PC250004: Private Plan Change Request to the Partially Operative Selwyn District Plan from Yoursection Limited at 1/487, 2/487 and 10/487 Weedons Road (V4) – Request for further information

Thank you for your application lodged on behalf of **Yoursection Limited** requesting a change to the Partially Operative Selwyn District Plan (PODP). In accordance with Clause 23 of Schedule 1 of the Resource Management Act 1991, the following information is requested to enable Council to better evaluate the potential effects of the proposal.

Figure 3: Indicative Green Belt cross section from Rolleston Structure Plan 2009 (figure 7.7)

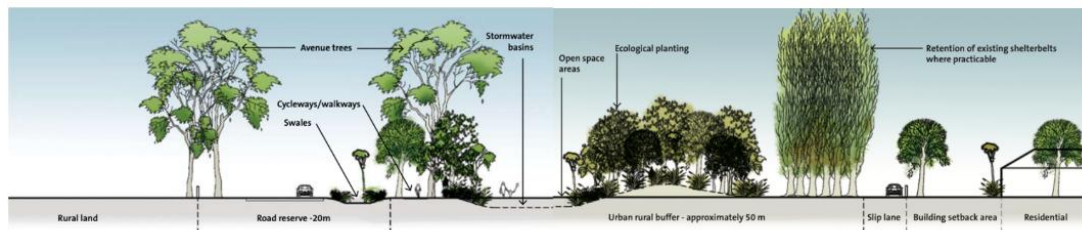
- 2.5. *The Rolleston Structure Plan 2009 also proposes a green belt along the urban rural boundary as indicatively outlined in Figure 3 below. While this has not been specifically implemented in other areas along the urban / rural boundary in Rolleston, it does highlight the need for some specific recognition and landscape treatment of this boundary.*

2.6. *I request recommendations for specific landscape treatments that would be appropriate along Weedons Road particularly in terms of tree planting and fencing rules.*
